Commonwealth Edison
One First National Plaza, Chicago, Illinois
Address Reply to: Post Office Box 767
Chicago, Illinois 60690

Subject: Braidwood Station Units 1 and 2
FSAR Change Concerning Project
Start-up Organization
NRC Docket Nos. 50-456/457

Enclosed for your advance information are changes to the Byron/Braidwood FSAR that fully explain our new Braidwood Project Start-up Organization. Our Byron/Braidwood FSAR Chapters 13 and 14 will be amended to include this information in the next Amendment.

Figure 13.1-3

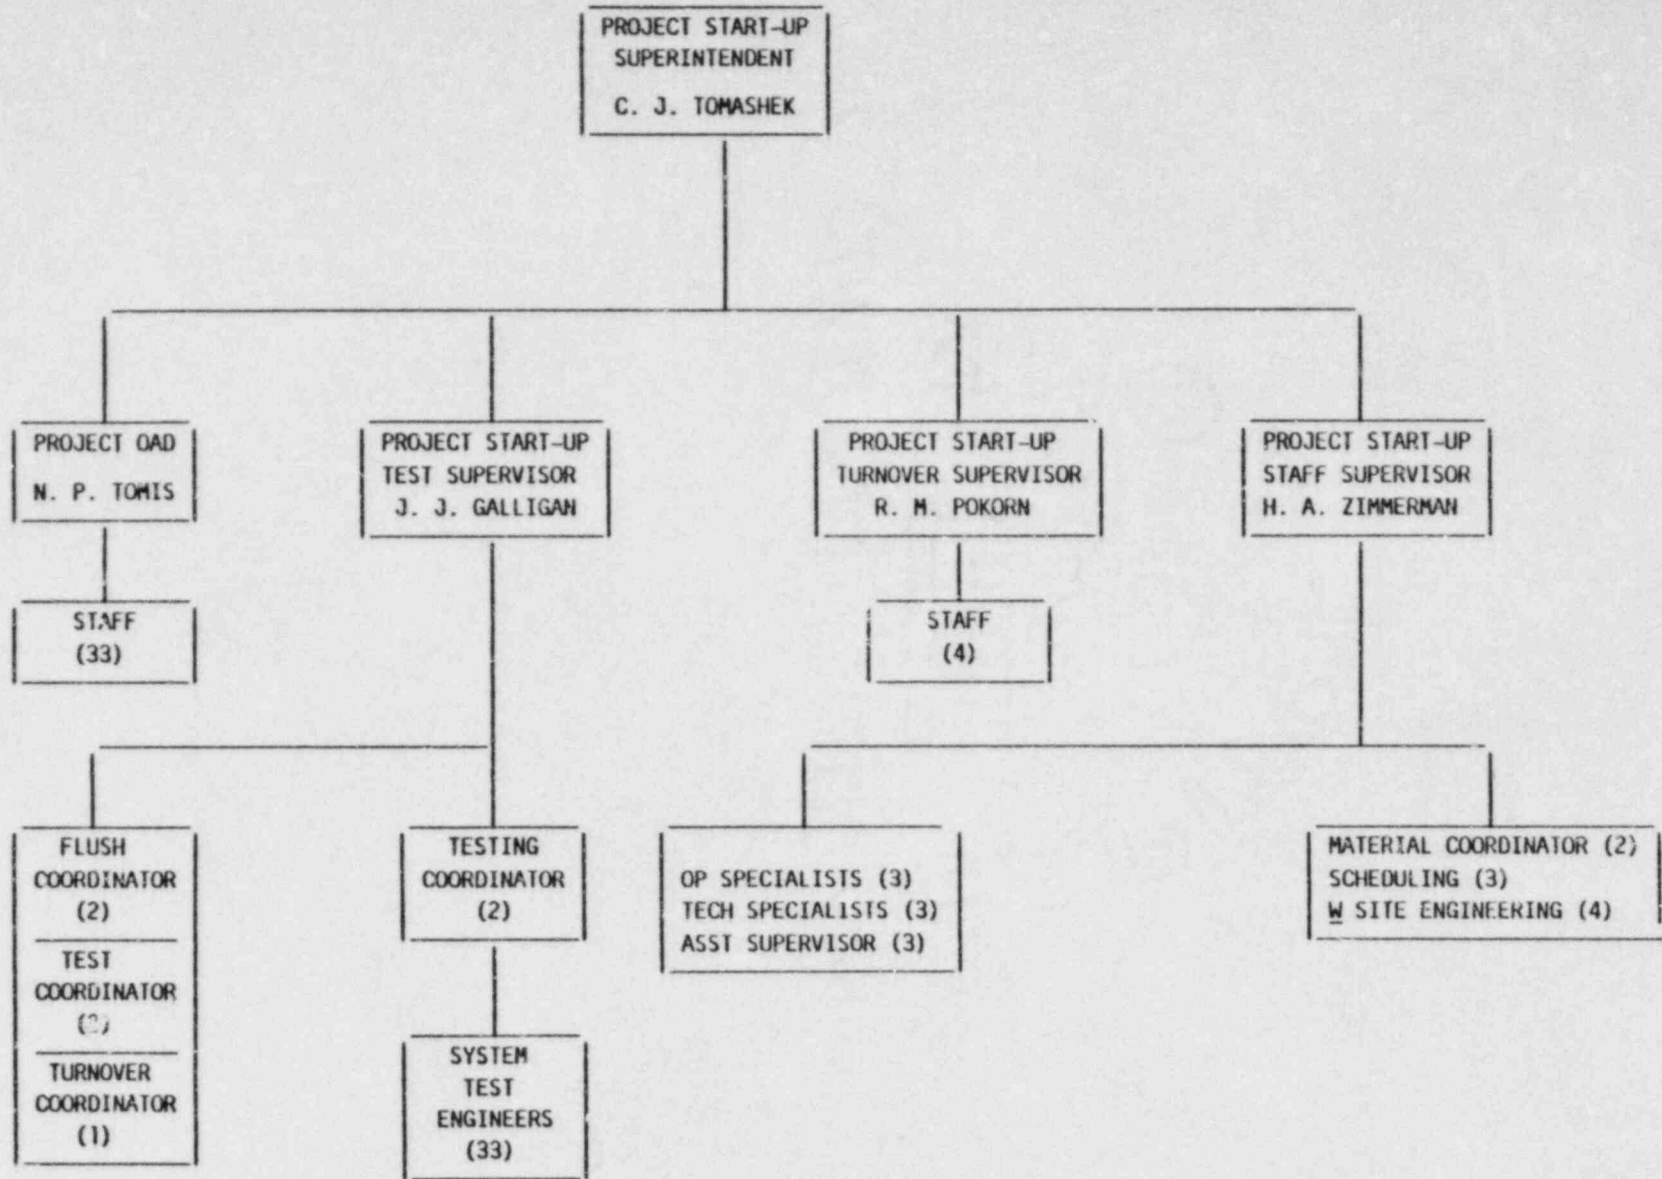
An organization chart of the Project Start-up Organization is provided in Figure 13.1-3.

This chart indicates the title of each position and the anticipated number of persons assigned to common or duplicate positions at the time of peak activity.
